Delegated Report

Subject: Windmill Road – Road Safety Improvement

1.1 This report presents the result of the statutory consultation carried out on the proposed Road Safety Improvement scheme and seeks Cabinet Member approval to proceed with the making of the relevant Traffic Management Orders (TMOs) and the implementation of the proposed measures as shown in Drawing No. Z38-261- 01 attached in Appendix 1.

TITLE
**GENERAL LAYOUT
PROPOSED SINUSOIDAL SPEED HUMPS**

Drawing No:
Z38-261-01

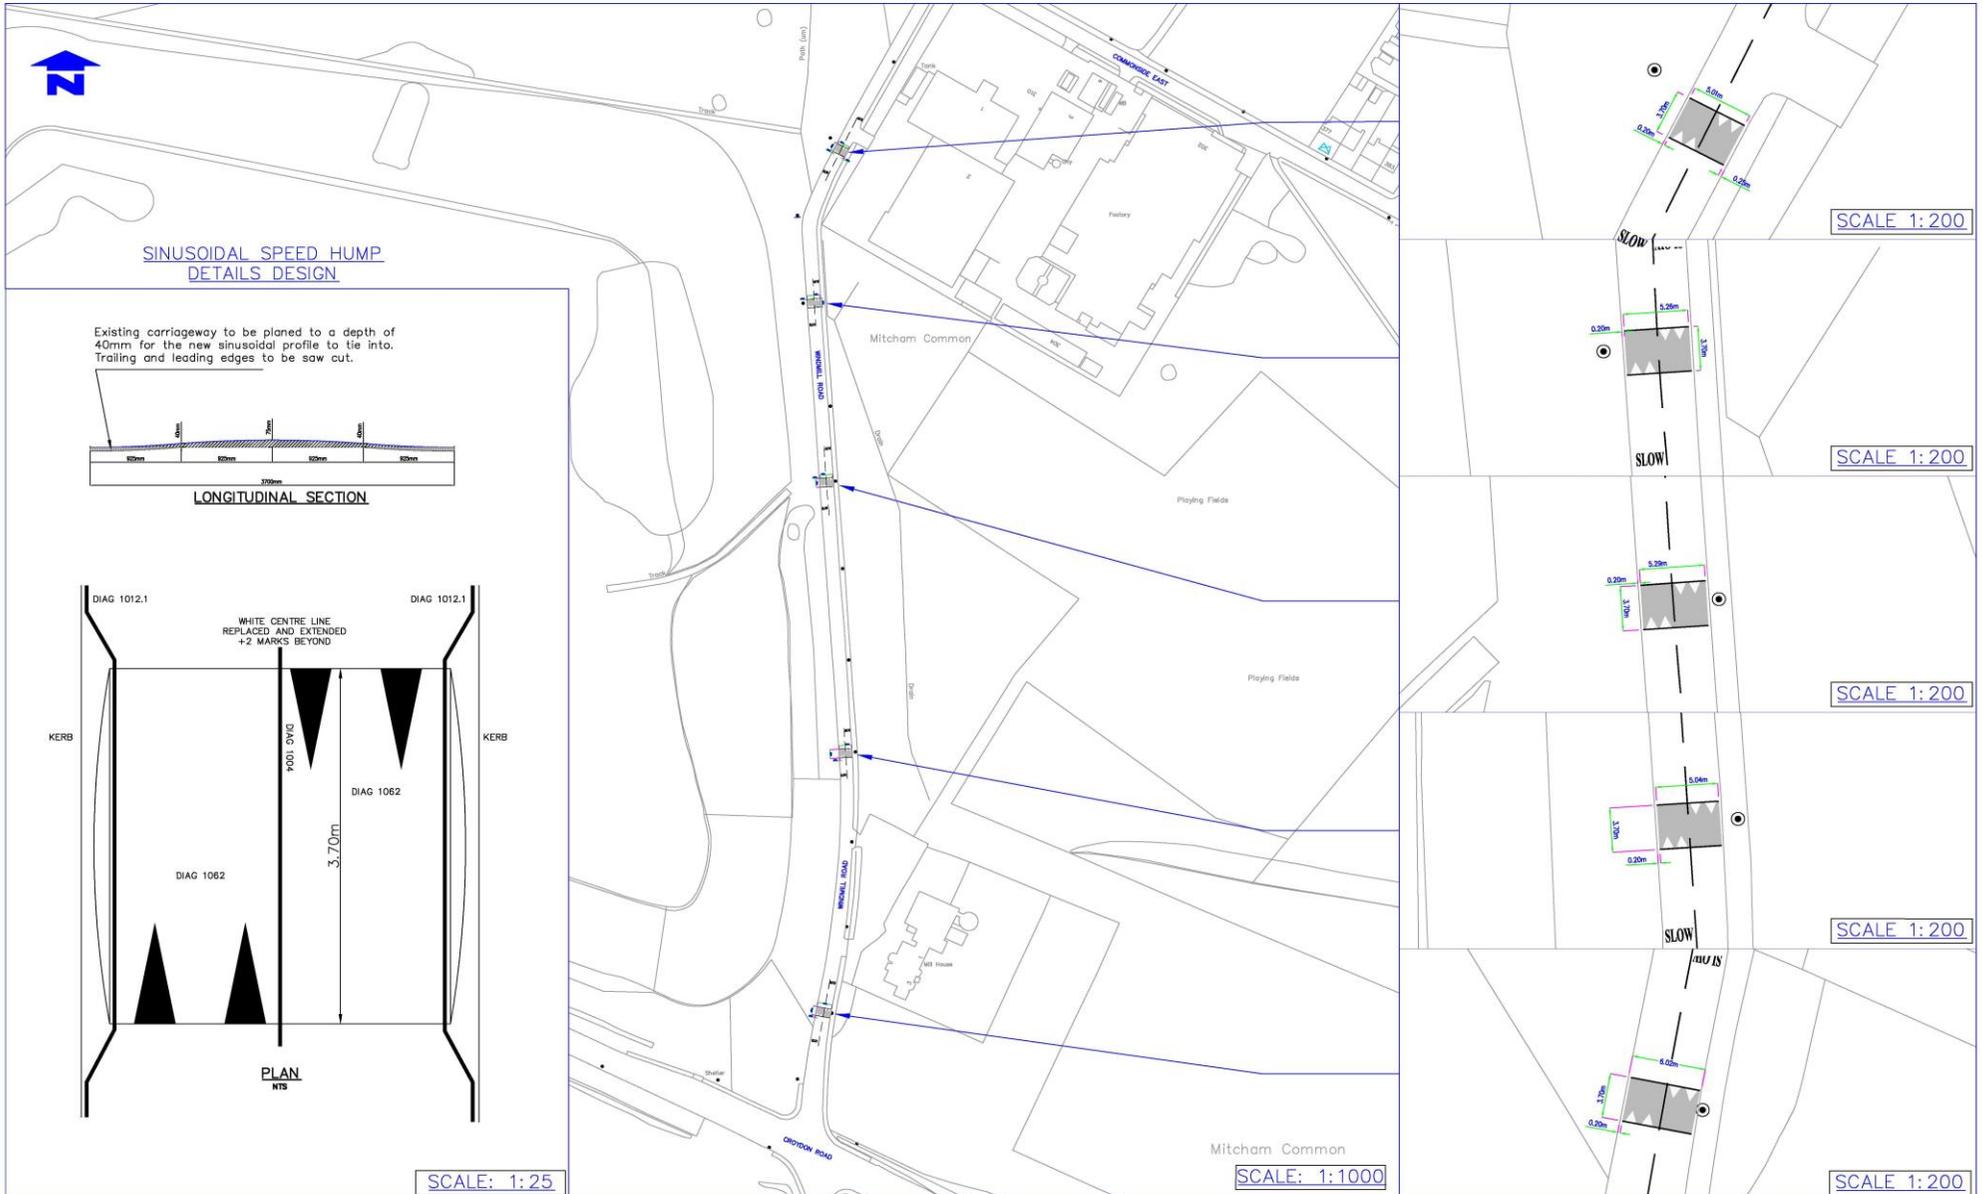
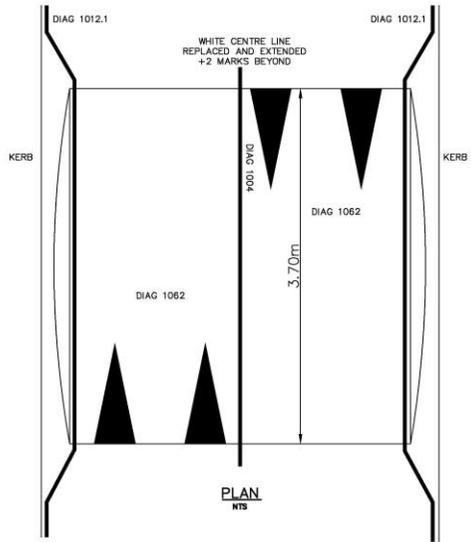
I wish to make object to your proposal to install speed humps on Windmill Road, Mitcham as published at <https://www.merton.gov.uk/streets-parking-transport/traffic-management-consultations/proposed-sinusoidal-humps-windmill-road>.

There are two reasons I object.

1. Many councils now have policies to not install new speed humps as they have been shown to create more problems than they solve. Examples are vehicles no longer drive at constant speed and instead accelerate and decelerate between humps. Driving at constant speed produces the least emissions, produces the least amount of noise, is safer, and reduces wear and tear on both vehicles and the carriageway. By promoting a regime of acceleration and deceleration, you are increasing emissions, engine noise, and reducing safety despite the temporary speed reductions. The Police, Ambulance service, Fire service, and bus companies, all oppose speed humps as they increase response times, endanger patients, and create occupational health hazards for those who are driving for a significant part of their day. Speed humps should not be used on any main road, or B road, or on roads where the speed limit is more than 15 mph.

2. Even though the humps you propose are sinusoidal, these still deter cyclists. Humps are not only exceedingly unpleasant to cycle over (regardless of whether or not they are sinusoidal), they are also significantly less safe for bicycles due to the changes of motion. Bicycles and their riders suffer even greater wear and tear when using speed humps than motor vehicles, which at least have suspension. The expected reduction in motor vehicle speed will not outweigh the deterrence caused by humps to cyclists. If a hump is significant enough to slow motor vehicles then it is too aggressive for cyclists. If the hump is so slight that it does not increase discomfort to cyclists, then it won't be effective in slowing motor vehicles anyway. It is my understanding that, unless you have a separated cycle lane, then you are obliged to install speed humps so they traverse the whole of the carriageway. If my understanding is incorrect, then if you must install speed humps, please do so only from the centre of the carriageway until 1.5 m from the kerb. Cars will not be able to avoid the speed hump / cushion, due to this road being so narrow, but at least cyclists won't be adversely affected by the humps as they will not be obliged to cycle over them.

3. Comment 2 and the title of your proposal, "Windmill Road Safety Improvements" invites us to consider what is the better solution. Windmill Road is a busy, congested road. It is also horribly narrow and it is not possible for motor vehicles to safely pass cyclists without crossing over to the lane on the opposite side of the road. Instead, cars squeeze past cyclists, against the rules of the Highway Code. Thankfully, the road has unremarkable grass along the side of it, with trees set back from the road. The obvious solution is to widen the carriageway and install proper, high quality 2.0 m wide, at-any-time cycle lanes, on both sides of the carriageway or, if there is likely to be a bus route on this road in the future, a bus lane in each direction as this would protect both cyclists and encourage use of priority traffic (cyclists, buses, motorcycles etc). At the same time, take the opportunity to widen the carriageway and at the Windmill Road x Croydon Road junction, so that there is a separate right-turn lane for vehicles turning right from Windmill Road on to Croydon Road. This will significantly alleviate this miserable bottleneck, which not only improves pollution, and costs to individuals and business of pointlessly wasting time, but also mitigates the stress of drivers who are caught up in this junction, which is not fit for purpose and a one of the worst bottlenecks in the borough. Stressed drivers are not safer drivers and are more likely to put their foot down in frustration at escaping from the significant, imposed congestion that this junction creates.

I am writing to object to the sighting of five sinusoidal humps in Windmill Road.

Recently there has been the introduction of a 20 mph that slows vehicles down considerably in a road which has a bend which slows traffic down, and there is often a build up of 10-20 vehicles from the Croydon Road.

I therefore strongly object to the proposed installation of even more humps in Mitcham for health reasons (back problems) and emissions from cars as they speed up after negotiating each hump. I also object to the expense of installation of humps where it is not necessary and the considerable disruption to traffic whilst road works take place.

Merton Council does have a duty to improve road safety and this is achieved by using the tools available to the Council. Although compared to previous years, the Council has minimised the introduction of vertical features mainly in residential roads due to the noise and vibration associated with such features. On this occasion, it is considered necessary to address speed and the safety and the proposal as approved by DfT are the appropriate features.

These road humps have been used elsewhere in the borough and they have not raised any concerns by any road users such as cyclists. Infact in roads where it is a cycle route, the Council has previously introduced such a feature without any objections before or after implementation.

Road humps installed at regular intervals along a section of a carriageway is designed to maintain a reduced constant speed; it is acknowledged that there are those very few who may speed and slow when using a traffic calmed road but it is considered that the benefits are greater than those very few who are unlikely to abide by traffic laws regardless. The road humps are likely to minimise risks to cyclists as vehicles would be travelling at lower speed and given the narrow nature of the road, unlikely to make any attempts in overtaking cyclists.

The land that abuts Windmill Road is Common Land and previous requests to establish a footway and undertake improvement work have been rejected. The Council is therefore unable to widen the carriageway.

Given the number of accidents and recently introduced 20mph speed limit, the Council is obliged to ensure that safety is improved and motorists abide by the speed limit.

Track trials at TRL, measuring passenger discomfort, have shown that, compared with a round top hump, a sinusoidal hump would produce a small reduction in discomfort for cyclists (both humps 75mm high, 3.7m long). The trial indicated that there was little, if any, benefit in terms of driver or passenger discomfort for car or bus passengers in using a sinusoidal hump in preference to a round-top hump or in using sinusoidal ramps in preference to straight ramps.
